Metropolitan Planning Commission

Staff Reports

November 19, 2015

Proposed Site Plan

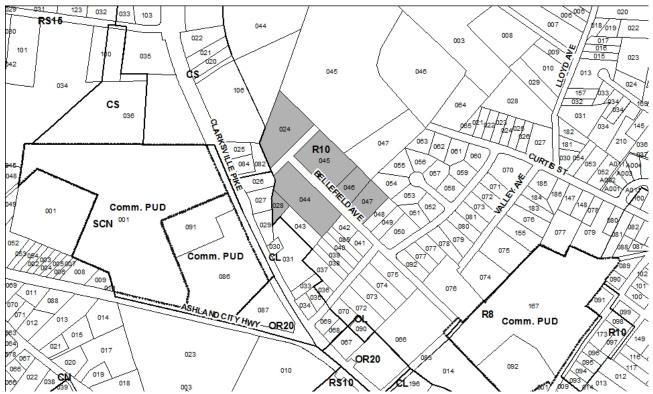
No, the Preliminary SP is inconsistent with the T4 NM policy. The proposed plan does not maintain the character of the predominantly single-family neighborhood. The higher intensity development proposed by this plan is inappropriate in a midblock context. The massing and orientation of the development does not match the development pattern of the surrounding community and access along James Avenue is not consolidated.

The Preliminary SP is inconsistent with the T4 Urban Neighborhood Maintenance policy. The intensity and orientation of the courtyard units do not maintain the character of the existing single-family neighborhood. The proposed zone change is inconsistent with the policy and needs to be accompanied by a Community Plan Amendment application for a policy that would support such a development. The Community Plan Amendment application would need to be evaluated for its appropriateness. [Note: The applicant originally submitted a policy change application for the subject property. Staff recommended expanding the area to include more than just one lot since staff would not support a policy change that is not comprehensive in nature. The applicant chose to withdraw their policy change request and go forward with just a zone change application.]

- Provide flow data and sq. footages for the units. Inadequate flow would require the living units to be sprinklered.
- The rear units will require FD access from the alley.
- Fire Code issues for the structures will be addressed at permit application review.

- Approved as a Preliminary SP only.
- Public sewer construction plans must be submitted and approved prior to Final SP approval. These approved construction plans must match the Final Site Plan/SP plans.
- The required capacity fees must also be paid prior to Final Site Plan/SP approval.

Staff recommends disapproval because the request is inconsistent with the T4 NM policy for the area.

- 1. Permitted land uses shall be limited to up to 8 residential units.
- 2. Add the following note to the plan: The final site plan shall depict a minimum 5 foot clear path of travel for pedestrian ways, including public sidewalks, and the location of all existing and proposed obstructions. Prior to the issuance of use and occupancy permits, existing obstructions within the path of travel shall be relocated to provide a minimum of 5 feet of clear access.

- 3. Access for Units 1 and 2 shall be limited to a single joint access driveway.
- 4. The Preliminary SP plan is the site plan and associated documents. If applicable, remove all notes and references that indicate that the site plan is illustrative, conceptual, etc.

Proposed Site Plan

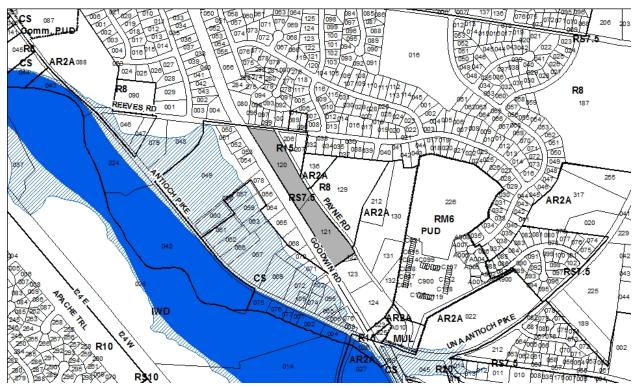
• Recommend approval with the condition that any exterior alterations be reviewed by MHZC

- The developer's final construction drawings shall comply with the design regulations established by the Department of Public Works. Final design may vary based on field conditions.
- Comply with MPW Traffic Engineer
- Indicate on the plans the location of a dumpster for solid waste and recycling container on site.

• Redesign parking layout in rear lot to provide parking per metro code at a minimum. Revised layout shall be addressed with permit plans.

• Approval does not apply to private water and sewer line design. Plans for these must be submitted and approved through a separate review process with Metro Water Permits, before their construction may begin.

- 1. Prior to issuance of a Use and Occupancy (U&O) permit, modify existing head-in parking located within Shelby Avenue right-of-way to parallel parking spaces.
- 2. Signage is limited to an existing sign; no additional signage will be permitted.
- 3. Residential uses shall be limited up to a maximum of six units.
- 4. Office uses shall be limited up to a maximum of 5,457 square feet.
- 5. Retail uses shall be limited up to a maximum of 1, 230 square feet.

Proposed Subdivision

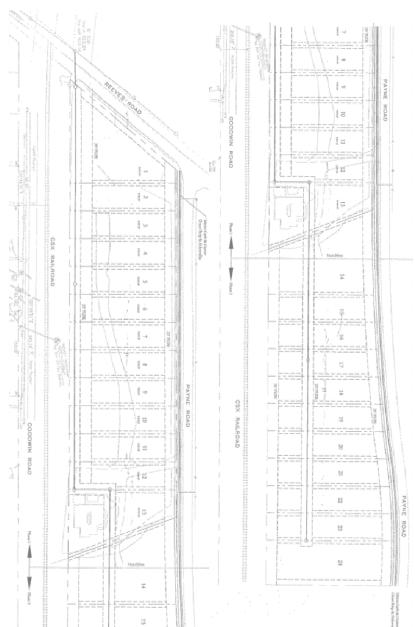
The proposed subdivision is in a Neighborhood Maintenance policy. The Subdivision Regulations require that infill lots in previously subdivided and predominately developed areas be consistent with surrounding lots in terms of lot size and lot width at the street. Staff finds that the proposed lots do not have to meet this requirement because Payne Road does not contain any previously platted lots nor is the area predominately developed.

Fire Code issues for the structures will be addressed at permit application review. Hydrants shall be located within 500' of all parts of every structure via approved hard-surfaced roads.

- Payne Rd shall be widened to 1/2 of ST-251 Narrow Roadway detail on the development side, and provide a minimum of 20' of payement total.
- This development will require Public Works approval of detailed construction plans prior to grading the site. Plans must comply with the design regulations established by the Department of Public Works. Final design and improvements may vary based on actual field conditions.

• Trim vegetation as necessary along Reeves Rd frontage of lot 1 to provide adequate sight distance at Payne Road.

Returned for corrections

Staff recommends disapproval since Stormwater has not approved the plan. If Stormwater recommends approval prior to the November 19, 2015, meeting then staff recommends approval with conditions.

- 1. While a sidewalk is shown on the plan along Payne Road, the Subdivision Regulations would permit a contribution to be made to Pedestrian Benefit Zone 5-C in the amount of \$125,580 in lieu of constructing the sidewalk. The sidewalk requirements of the Subdivision Regulations shall be met prior to the final plat being recorded. If constructed the required dimensions include a six foot sidewalk and six foot planting strip.

- 3. Shift lot line between Lots 13 and 14 so that it is radial to Payne Road.
- 4. Any critical lot must be denoted on the final site plan and the final plat.

- 5. Payne Road shall be widened to 1/2 of ST-251 Narrow Roadway detail on the development side, and provide a minimum of 20' of total pavement.
